UNITED STATES DEPARTMENT OF COMMERCE United States Patent and Trademark Office Address: COMMISSIONER FOR PATENTS P.O. Box 1450 Alexandria, Virginia 22313-1450 www.uspto.gov

| APPLICATION NO. | FILING DATE | FIRST NAMED INVENTOR | ATTORNEY DOCKET NO. | CONFIRMATION NO. | |
|--|---------------|----------------------|---------------------|------------------|--|
| 10/585,461 | 05/27/2009 | Jun Taketatsu | 1303.46354X00 | 5965 | |

| | A 12 | A It A/-) | |
|--|--|---|--|
| Office Action Occurrence | 10/585,461 | TAKETATSU ET AL. | |

DETAILED ACTION

(Sugiyama et et al. Fig. 11, see below), discovering the optimum or workable ranges involves only routine skill in the art. *In re Aller*, 105 USPQ 233.

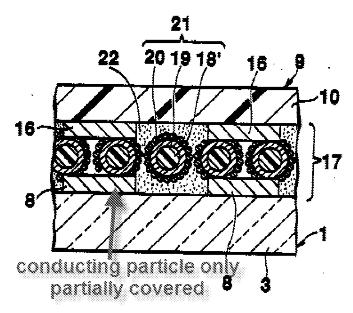
Regarding Claims 4, 19, and 20, Fukuzawa et al. in view of Sugiyama et al. discloses the claimed invention except for wherein in said covered particles, 5 to 60% of the surfaces of said conductive particles are covered by said insulating fine particles.

It would have been obvious to one having ordinary skill in the art at the time the invention was made to have range of coverage by the insulating fine particles, since it has been held that where the general conditions of a claim are disclosed in the prior art
